SUBJECT: ISSUANCE OF AMENDMENT NO. 99 TO FACILITY OPERATING LICENSE
NO. NPF-29 - GRAND GULF NUCLEAR STATION, UNIT 1 (TAC NO. M82280)

ATTACHMENT TO LICENSE AMENDMENT NO. 99

SAFETY EVALUATION BY THE OFFICE OF NUCLEAR REACTOR REGULATION
RELATED TO AMENDMENT NO. 99 TO FACILITY OPERATING LICENSE NO. NPF-29
ENTERGY OPERATIONS, INC.
GRAND GULF NUCLEAR STATION, UNIT 1
DOCKET NO. 50-416

FIGURE 3.2.1-1 MAPLHGR vs AVERAGE PLANAR EXPOSURE

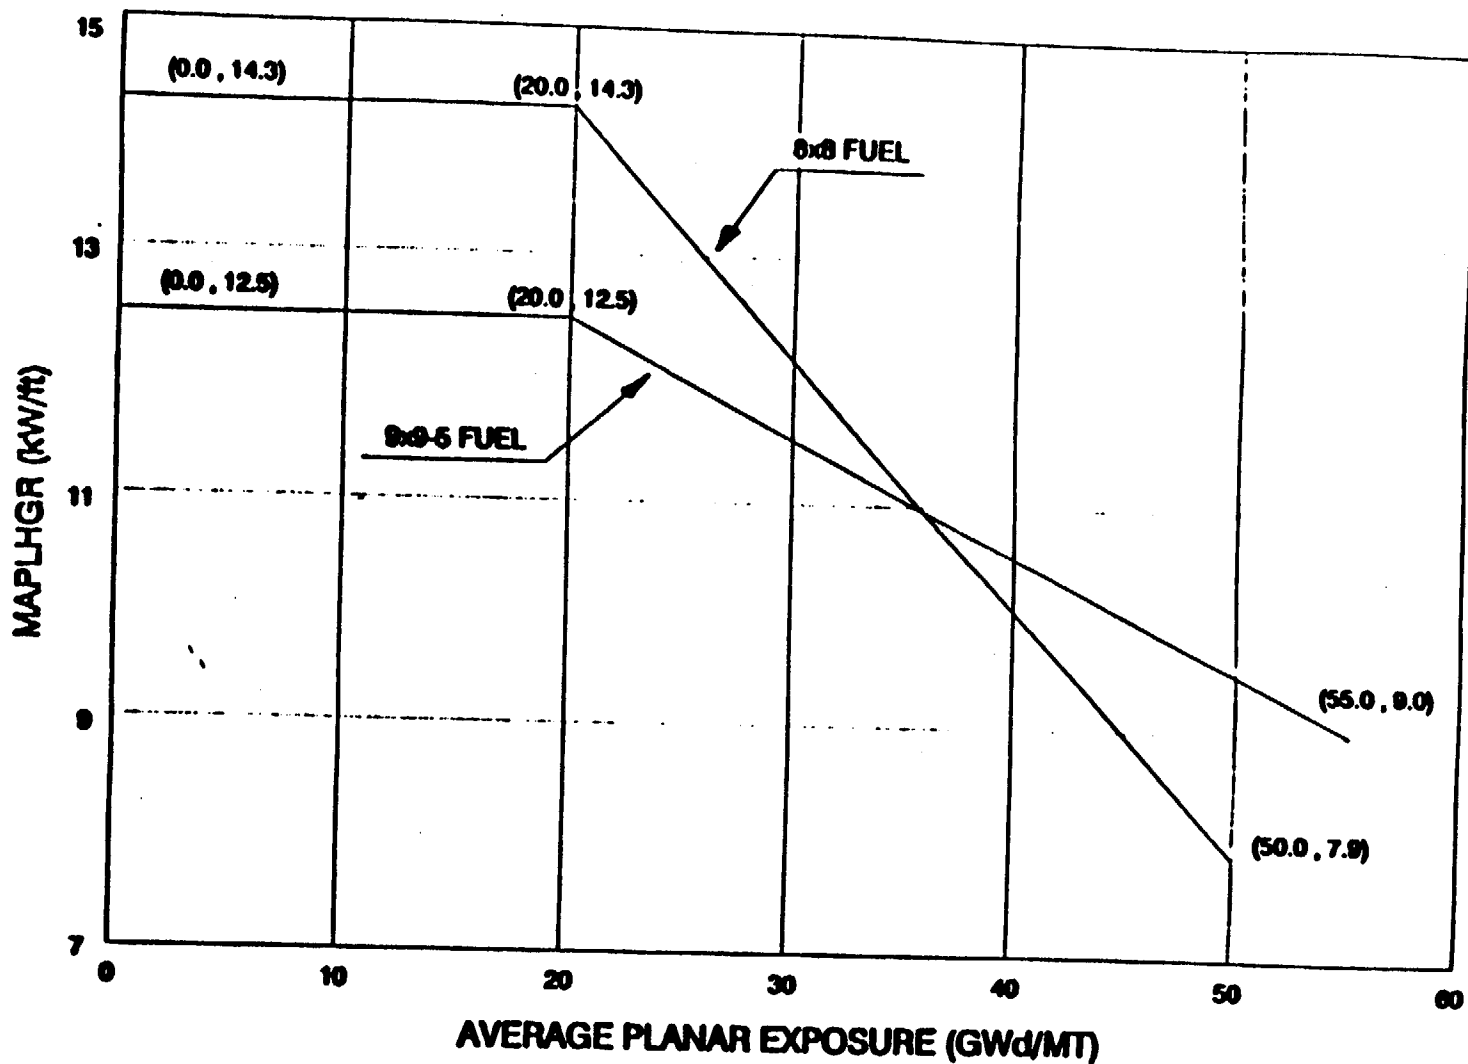
(2) TS 3/4.2.1

The SLO MAPLHGR multiplier is changed from 0.8 to 0.86. This change was based on SNP's detailed LOCA analysis for SLO.

During single loop operation, the APLHGR for each type of fuel as a function of AVERAGE PLANAR EXPOSURE shall not exceed the limit shown in Figure 3.2.1-1 multiplied by 0.86.

FIGURE 3.2.3-1 MCPR_f

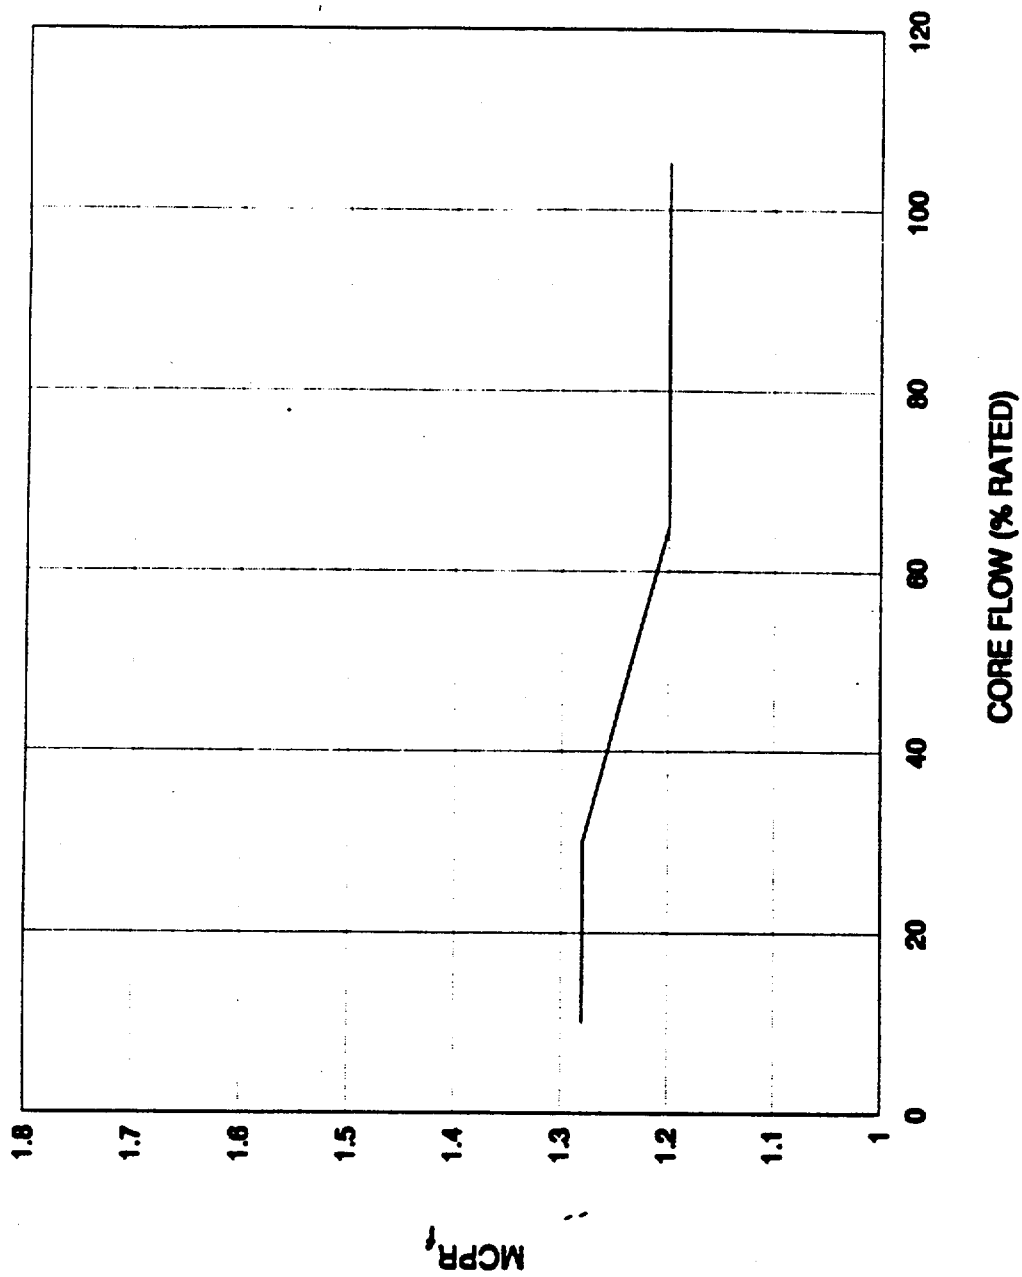
(3) TS 3/4.2.3 - Figure 3.2.3-1

Flow-dependent MCPR limits have been revised. The lower MCPR_f limits result from the lower MCPR safety limit and smaller delta-CPR values due to the improved transient response of the 9x9-5 fuel.

FIGURE 3.2.3-2 MCPR_p

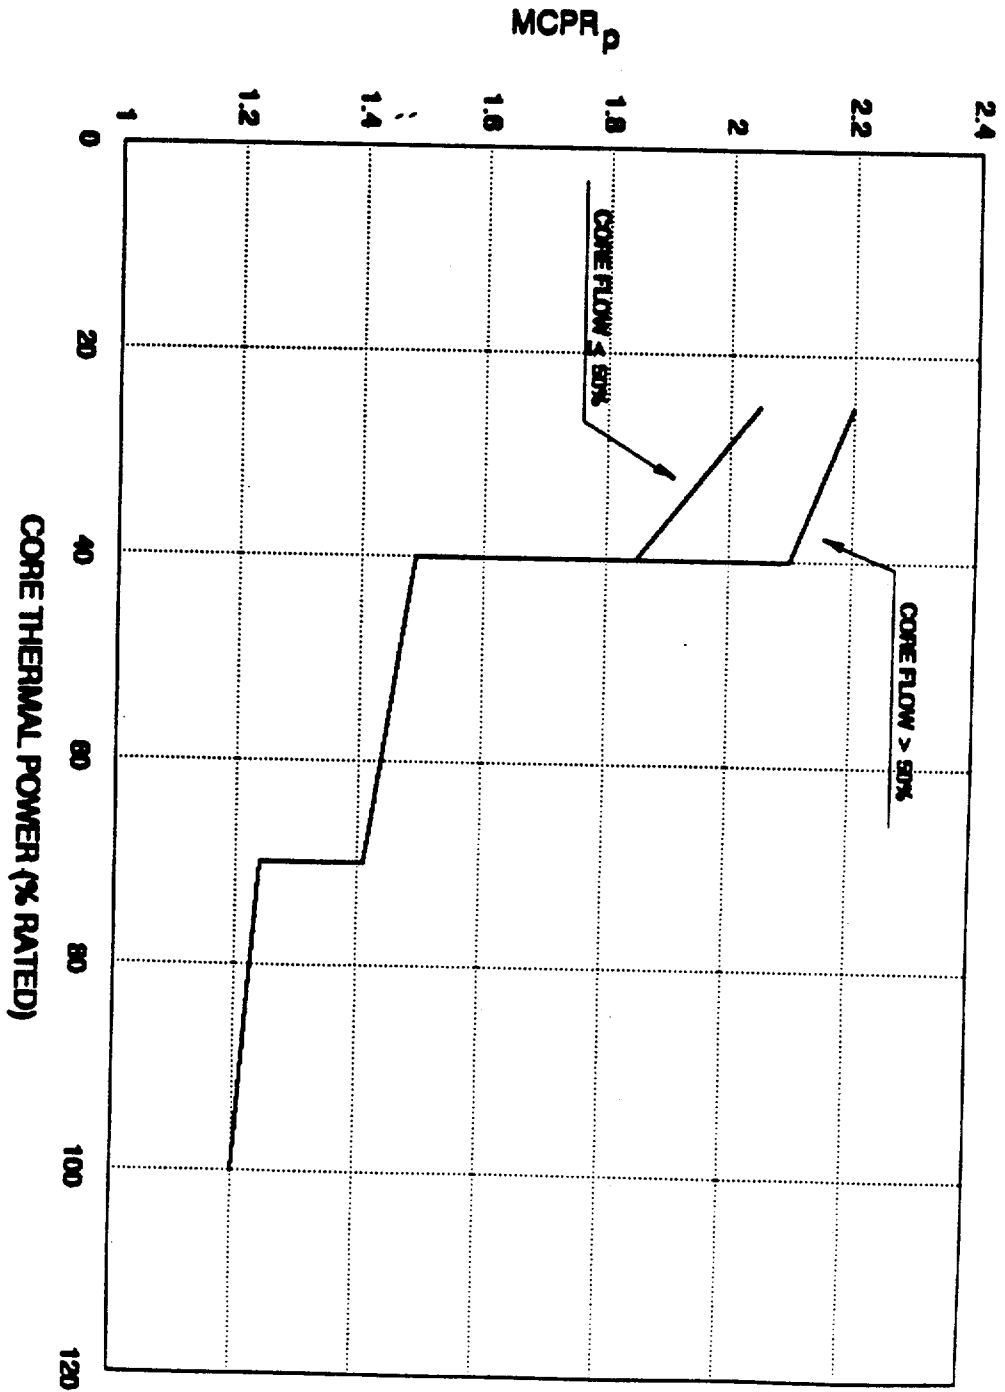
(4) TS 3/4.2.3 - Figure 3.2.3-2

Power-dependent MCPR limits have been revised to provide common MCPR_p limits for both TLO and SLO.

FIGURE 3.2.3-3 MCPR_e

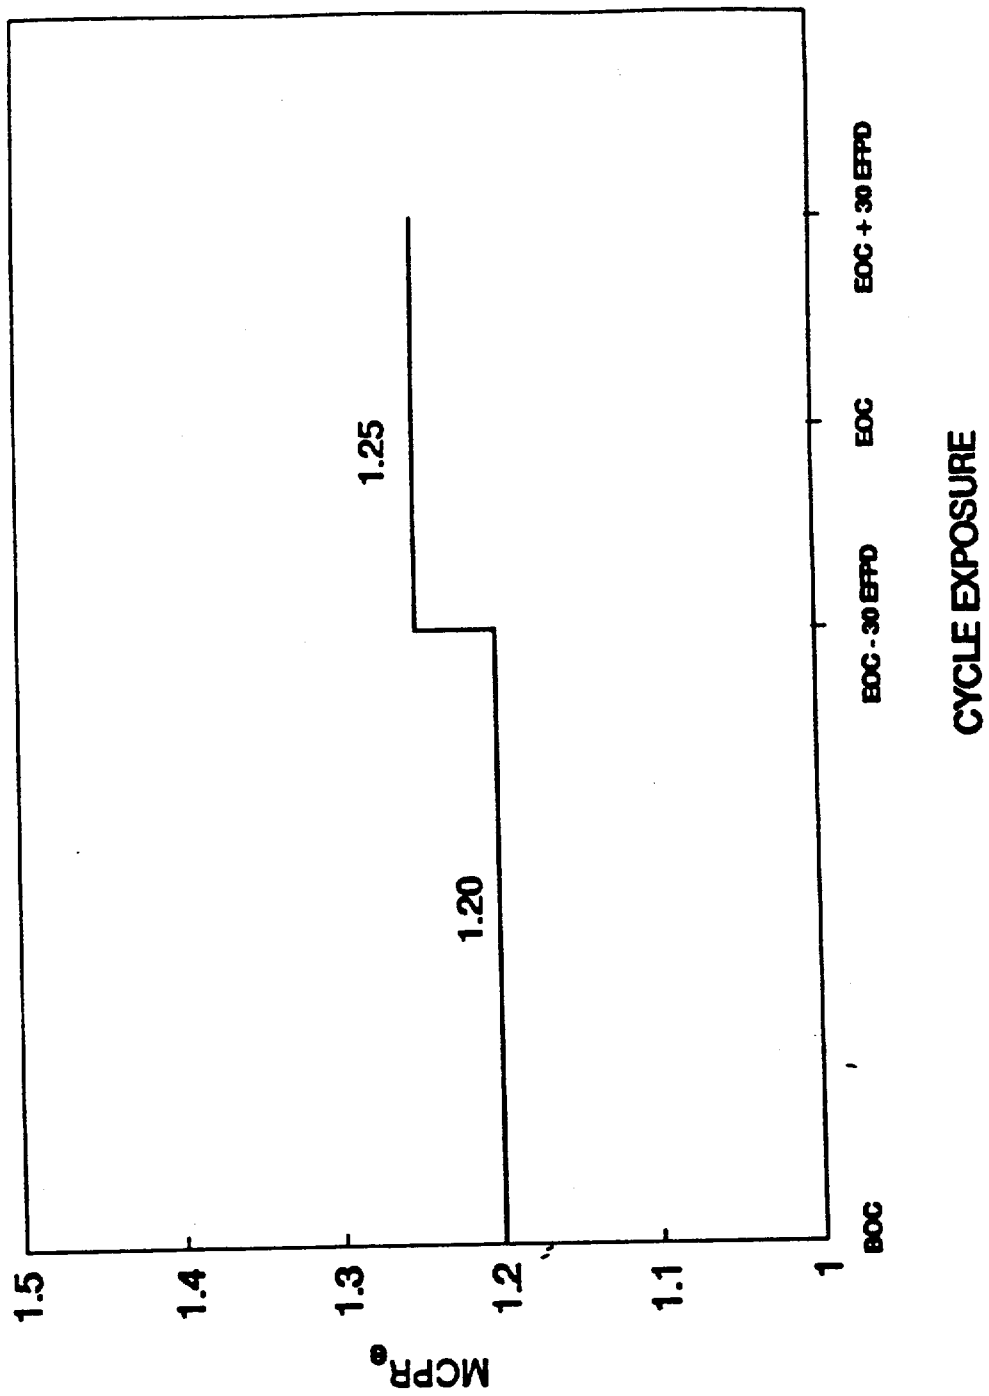
(5) TS 3/4.2.3 - Figure 3.2.3-3

Exposure-dependent MCPR limits have been revised to reflect the revision to the MCPR safety limit and the improved transient response of the Cycle 6 core.

FIGURE 3.2.4-1 LHGR vs AVERAGE PLANAR EXPOSURE

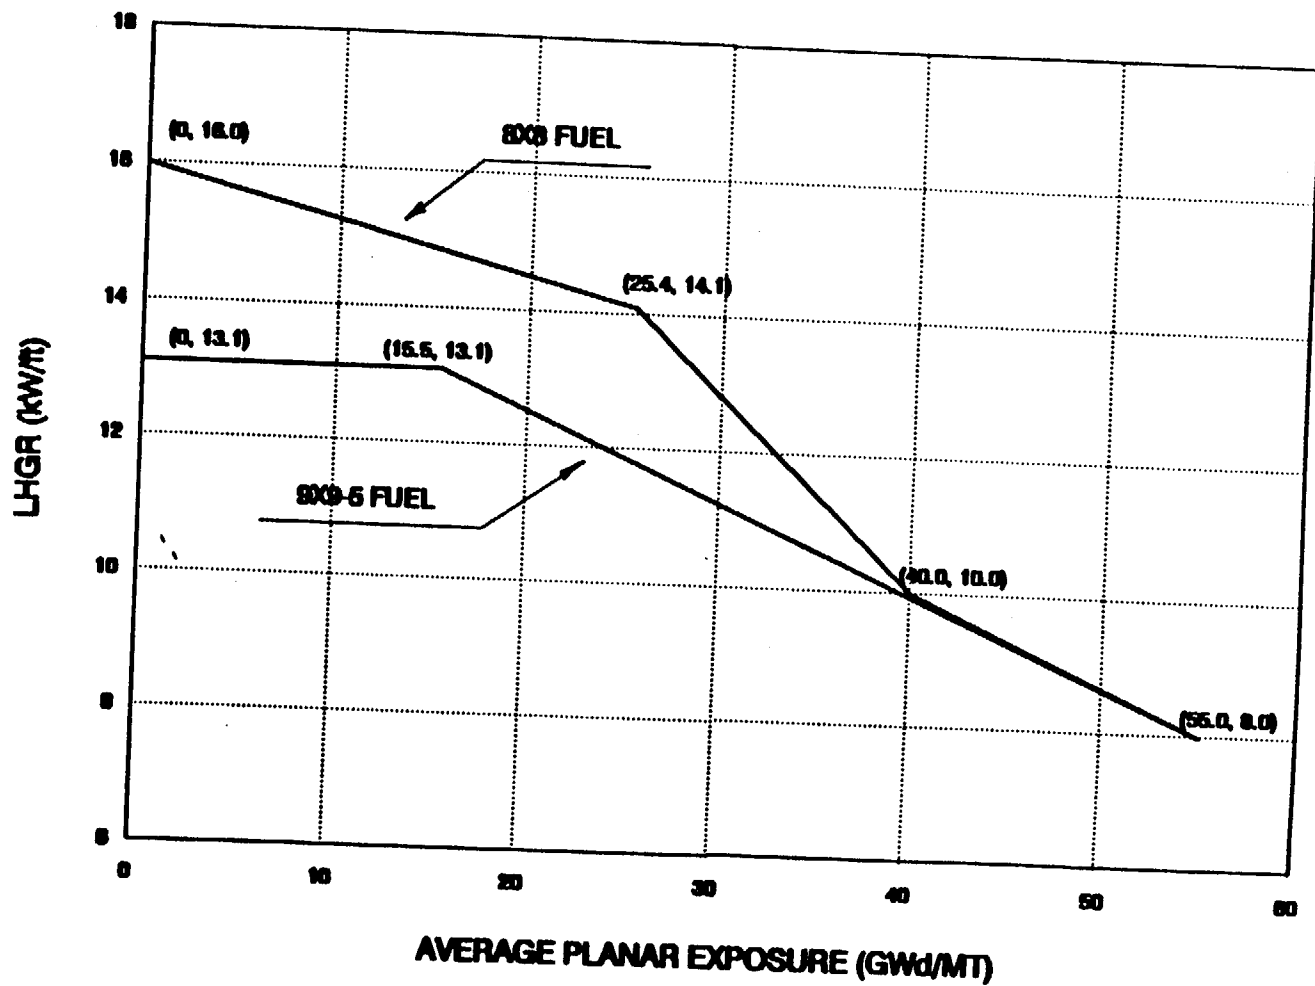
(6) TS 3/4.2.4 - Figure 3.2.4-1

LHGR limits for 8x8 fuel types have been increased for average planar exposures greater than 40,000 MWd/MTU in order to bound the LHGR performance for the 8x8 fuel near the end of Cycle 6.

FIGURE 3.2.4-2 LHGRFAC_f

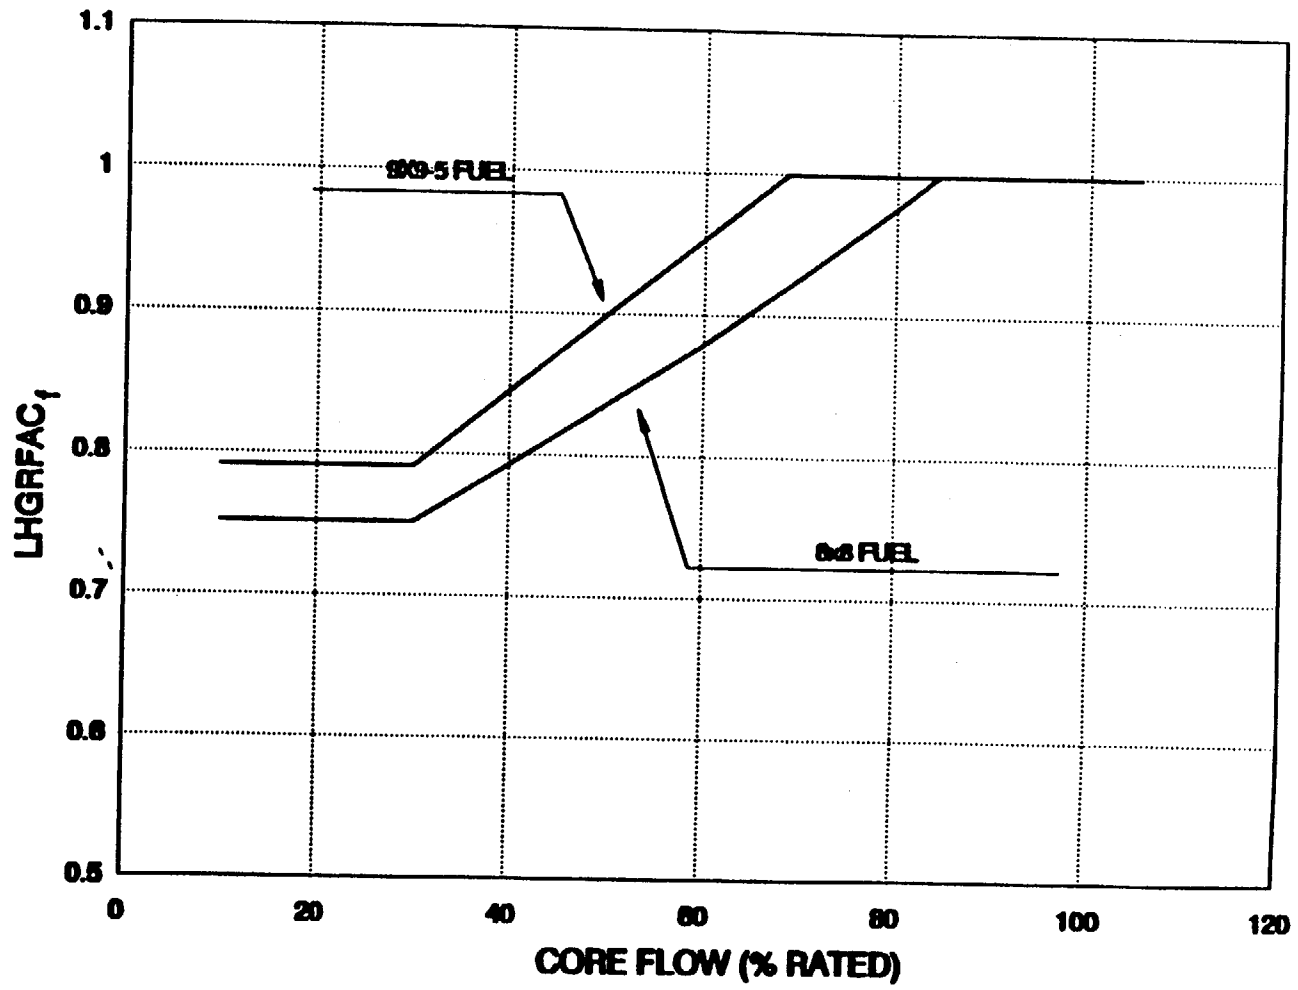
(7) TS 3/4.2.4 - Figures 3.2.4-2 and 3

Off-rated mechanical limits have been revised to reflect the predominantly 9x9-5 fueled core and the higher LHGR limit for SNP 9x9-5 fuel.
